**TO:** T10 Membership  
**FROM:** Paul A. Suhler, Quantum Corporation  
**DATE:** 31 August 2008  
**SUBJECT:** T10/07-469r8, ADT-2: Internet ADT (iADT)

### **Changes to ADT-2 rev. 5**

**Figure 3 – Example ladder diagram**

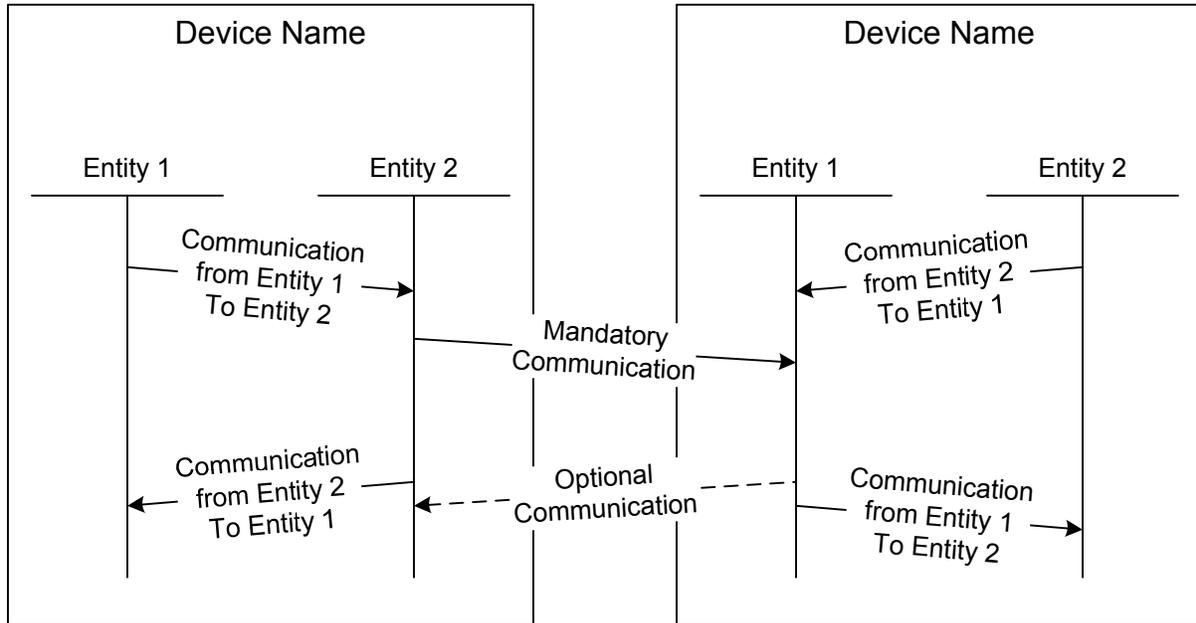
### 3.6.3 Notation for ladder diagrams

Ladder diagrams are used to indicate communication among entities within a device and among devices. All ladder diagrams use the notation shown in Figure 3. Each entity is indicated by a horizontal bar with a label on top of a vertical bar. Entities within the same device are enclosed by a box with a label at the top of the box. Each communication is indicated by an arrow with an optional label. Solid arrows indicate mandatory communications and dashed arrows indicate optional communications. Time flows from the top of the diagram (i.e., first communication) to the bottom (i.e., last communication).

**Figure 5 – ADT communication model**

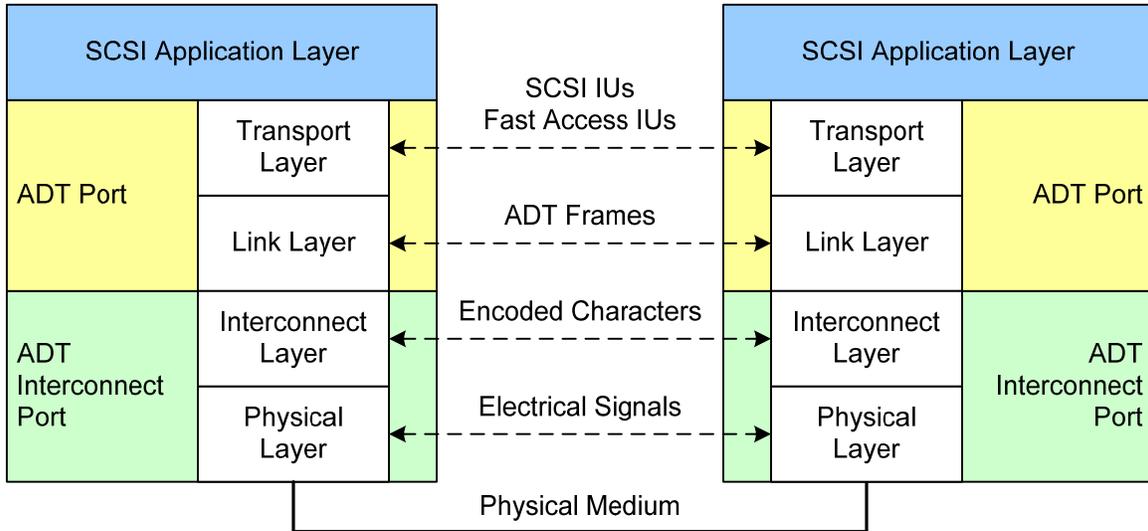
Figure 5 shows the communication between ADT ports and between ADT interconnect ports at the different layers of the protocol, from the physical layer to the SCSI application layer.

**Figure 8 – ADT serial port example**

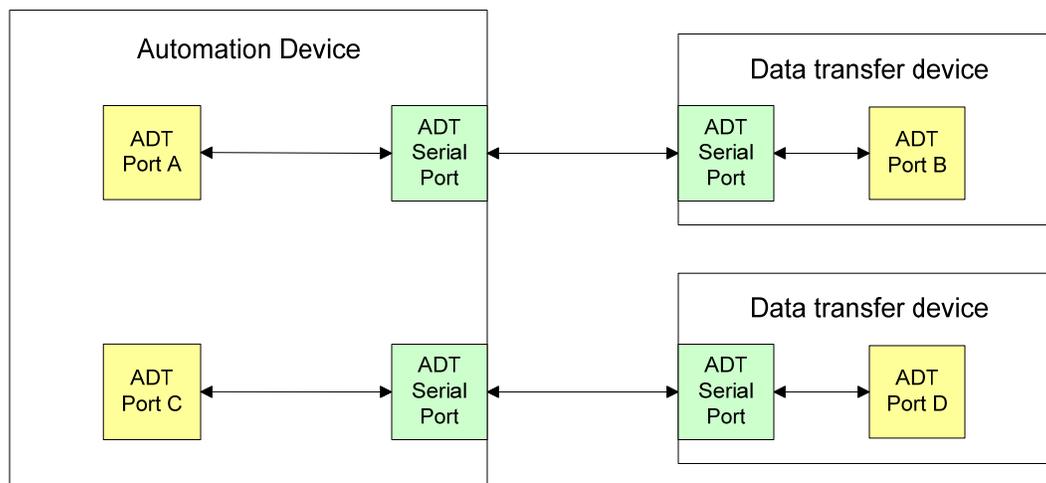
The term ADT serial port refers to an ADT interconnect port using the ADT serial transmit-receive connections (see 5.2.5.2) and the ADT serial interconnect layer (see 6.3). A single ADT port may use an ADT serial port for connection with another device. Figure 8 shows connections corresponding to Figure 4. ADT port A is connected with ADT port B, and ADT port C is connected with ADT port D.

Figure 9 – iADT port example

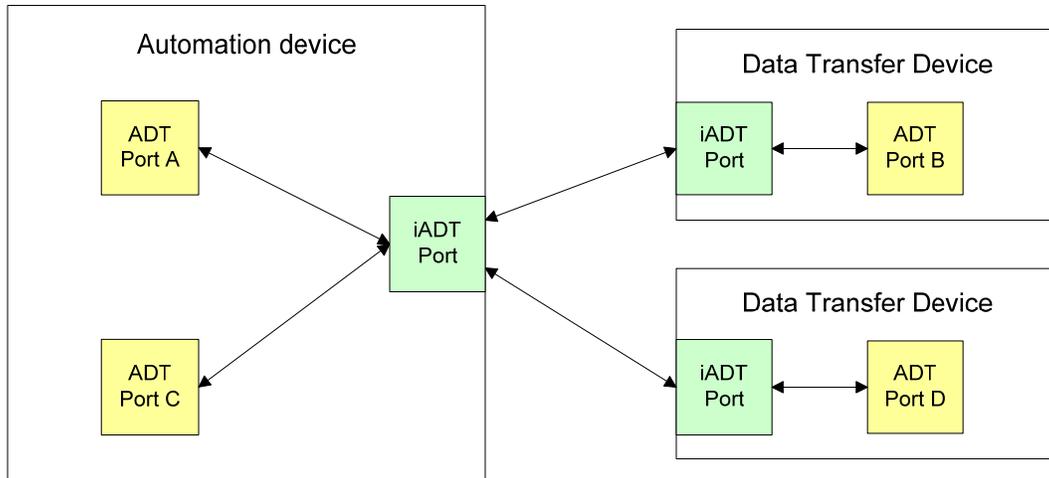
The term iADT port refers to an interconnect port using Ethernet transmit-receive connections (see 5.2.5.3) and the iADT interconnect layer (see 6.4). Multiple ADT ports in one device may share a single iADT port for connection to other devices. Figure 9 shows two pairs of ADT ports connected by iADT ports, corresponding to the connections shown in Figure 4. ADT port A is connected to ADT port B, and ADT port C is connected to ADT port D.

Figure 18 – Protocol services for establishing a connection between ADT serial ports.

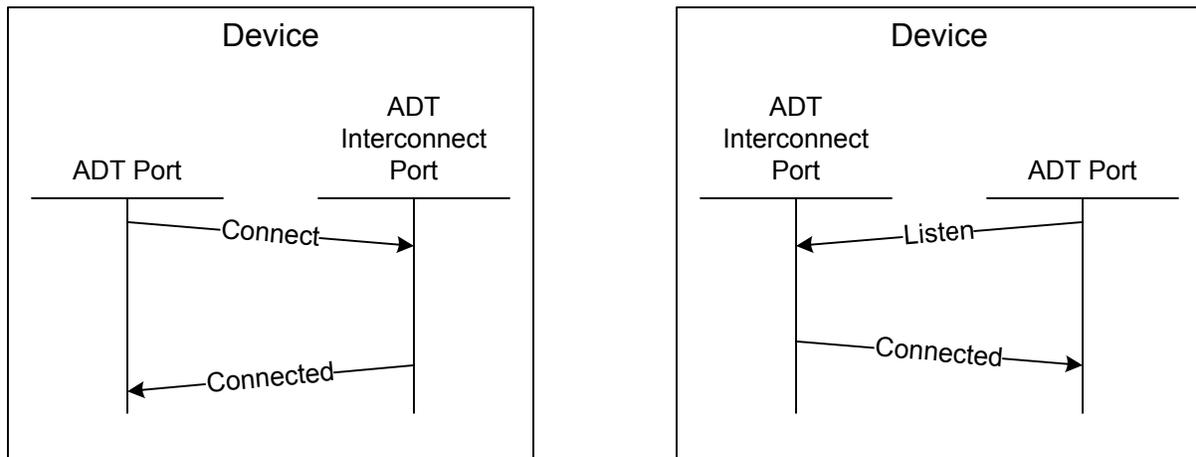
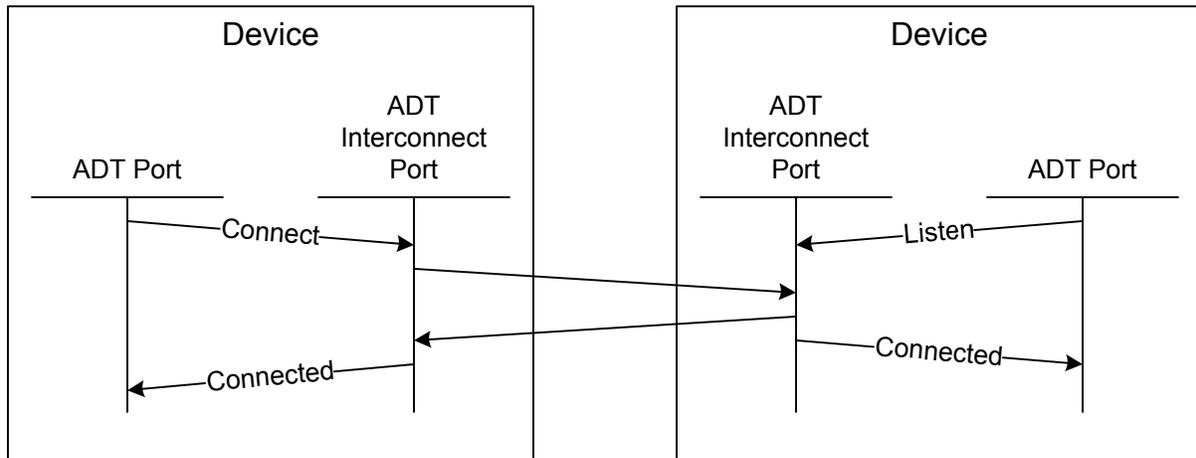
Figure 18 shows the relationships among the protocol services used to establish a connection between two ADT serial ports. When closing a connection, no communication takes place between the devices.

**Figure 18a – Protocol services for establishing a connection between iADT ports**

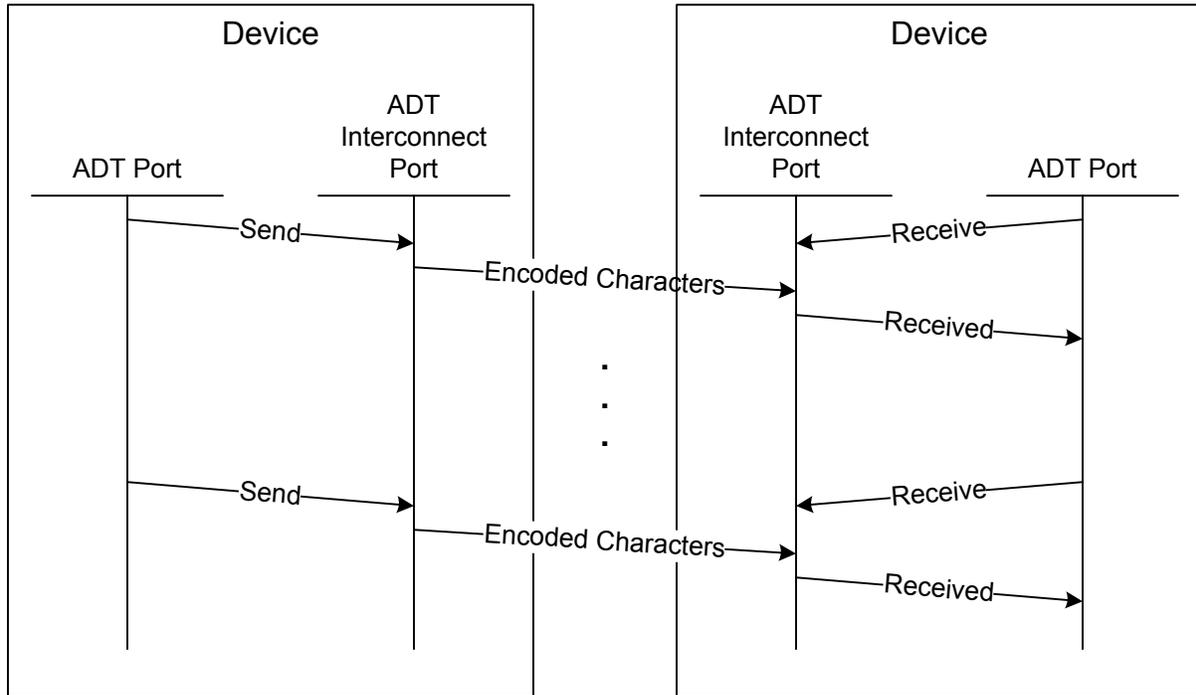
Figure 18a shows the relationships among the protocol services used to establish a connection between two iADT ports. The communication between the two devices is defined in RFC 793.

**Figure 19 – Protocol services for transferring data**

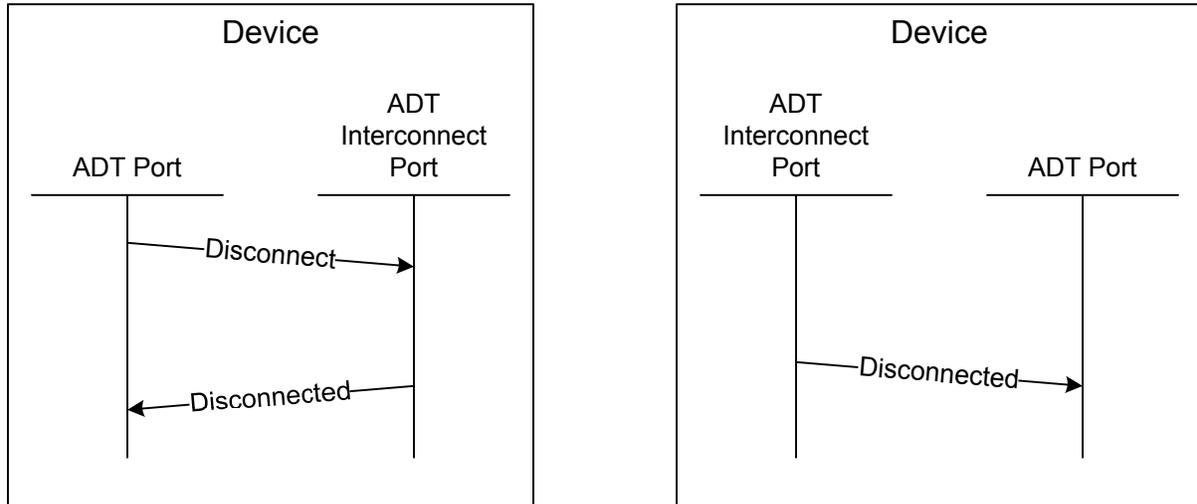
Figure 19 shows the relationships among the protocol services used to transfer data.

**Figure 20a – Protocol services for closing a connection**

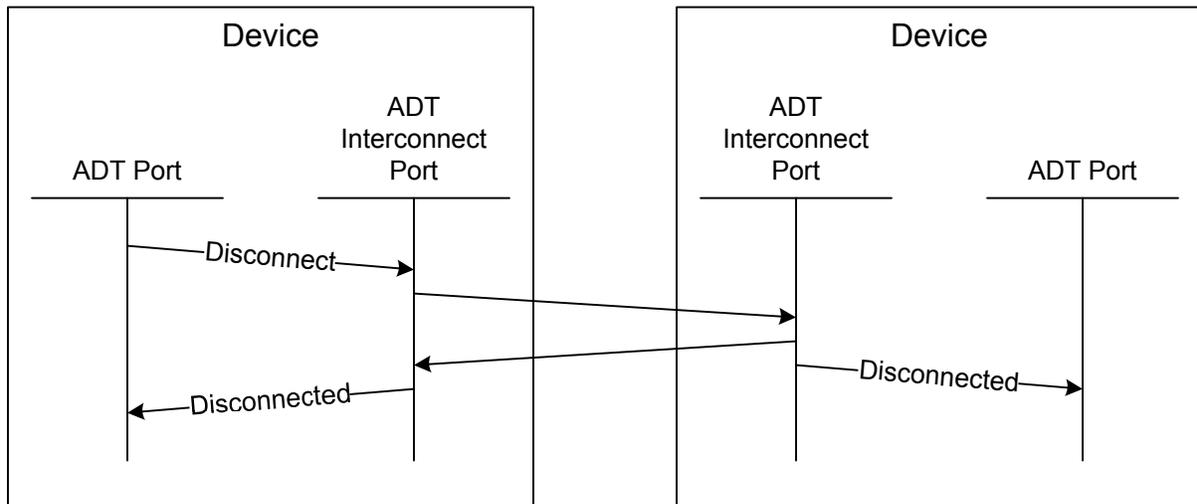
Figure 20a shows the relationships among the protocol services used to close a connection between two iADT ports. The communication between the two devices is defined in RFC 793.

**Figure 21 - Protocol services for performing a reset**

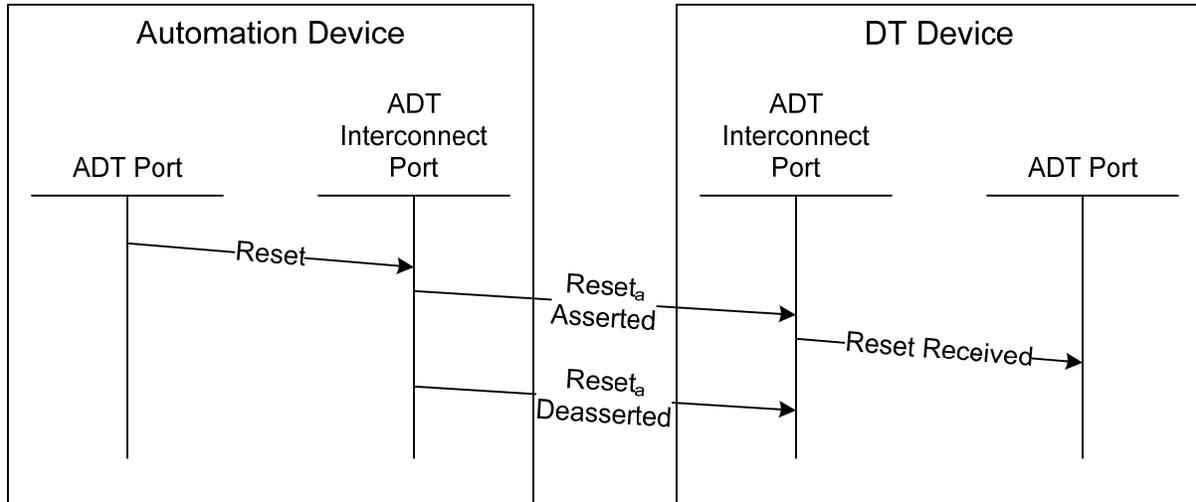
Figure 21 shows the relationships among the protocol services used to perform a reset.
